**Re: Petition of PPL Electric Utilities Corporation for Approval of Tariff Modifications
and Waivers of Regulations Necessary to Implement its Distributed Energy
Resources Management Plan
Docket No. P-2019-3010128**

DER Management Pilot Implementation Plan

Dated: February 28, 2023 (Second Revised)

Figure 3a - DER Management AMI Architecture

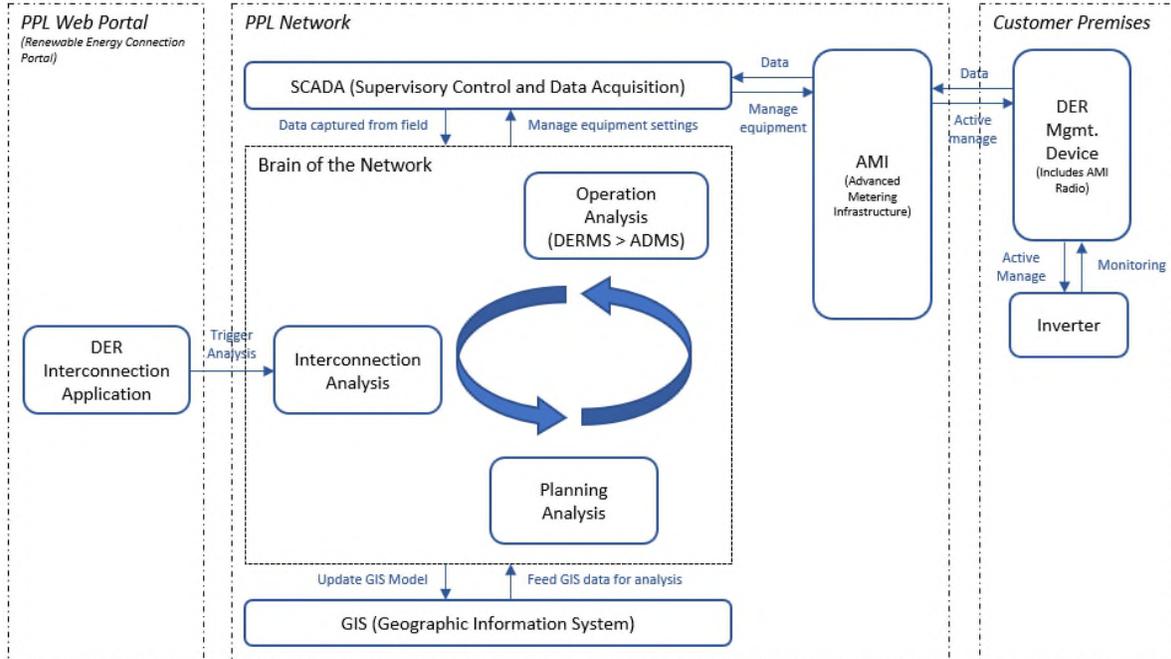
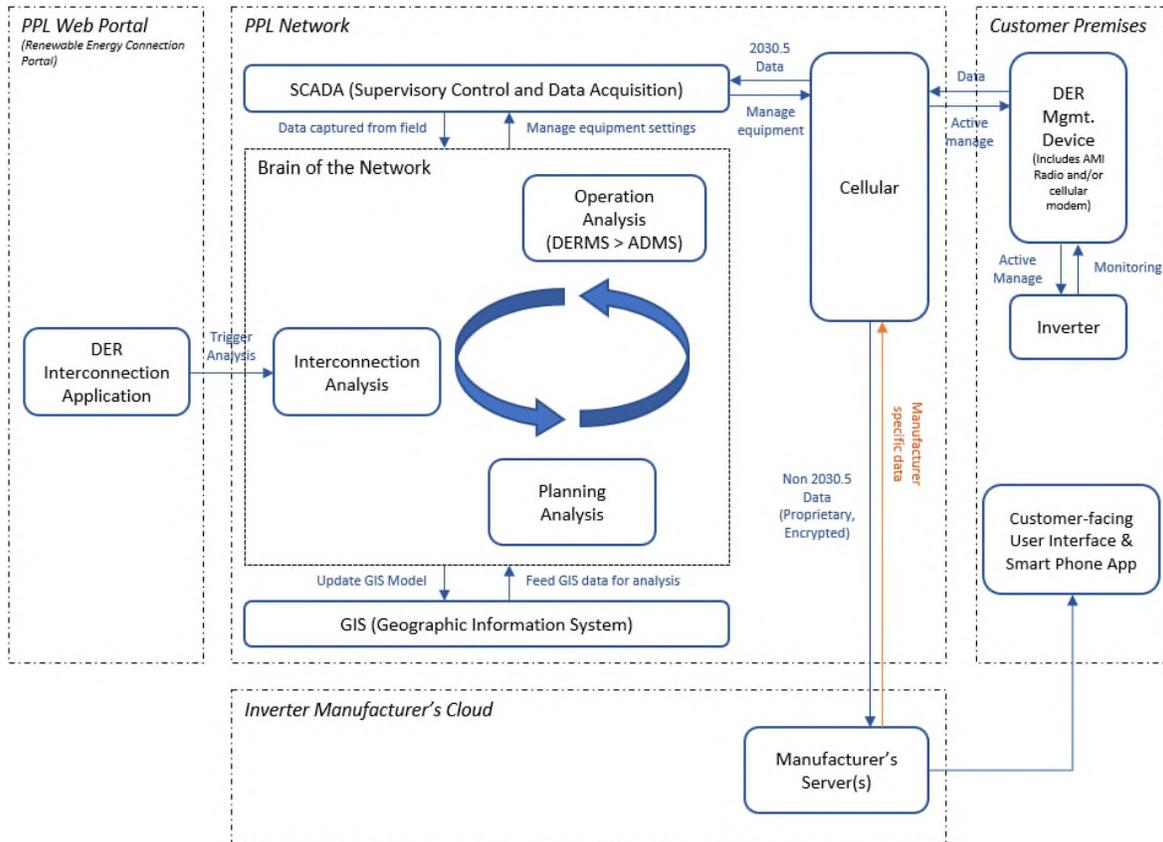
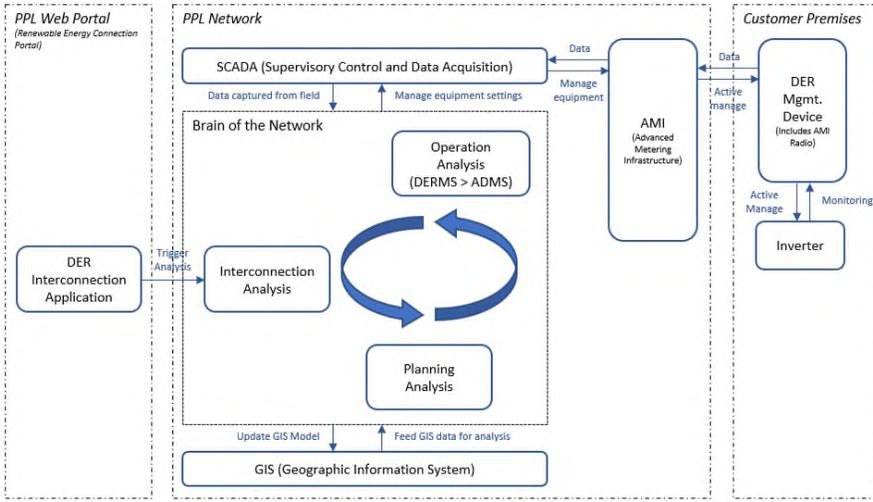
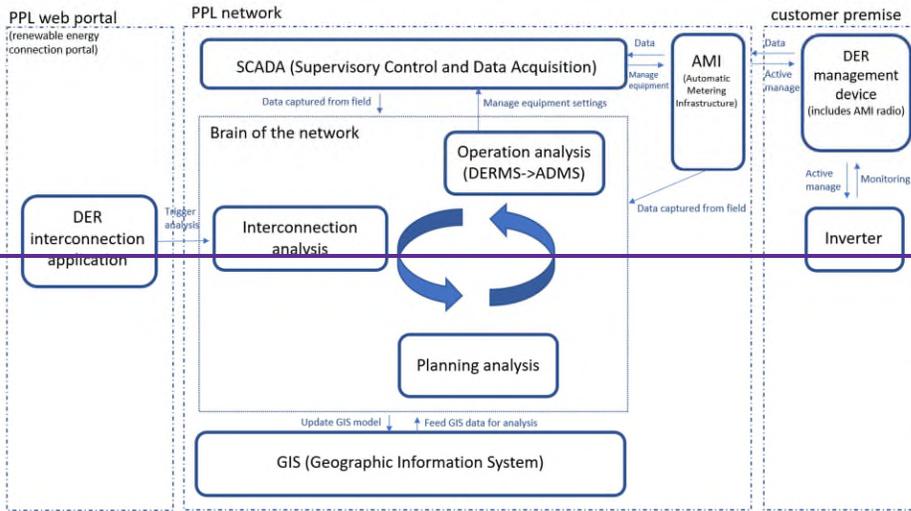
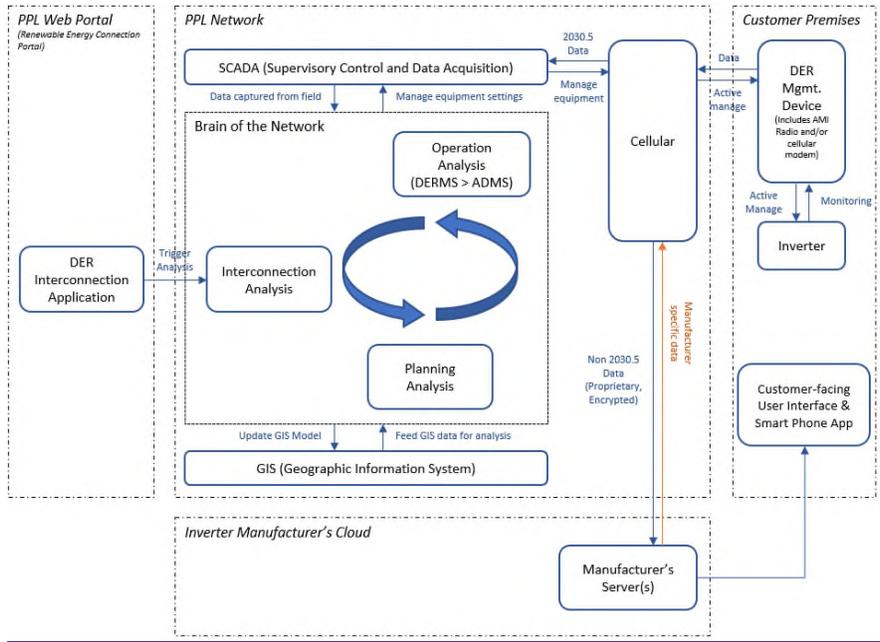
Clean and compare versions of the Second Revised DER Management Pilot Implementation Plan are enclosed. The compare version shows, in redline, the changes made to the Revised DER Management Pilot Implementation Plan filed on March 1, 2021.
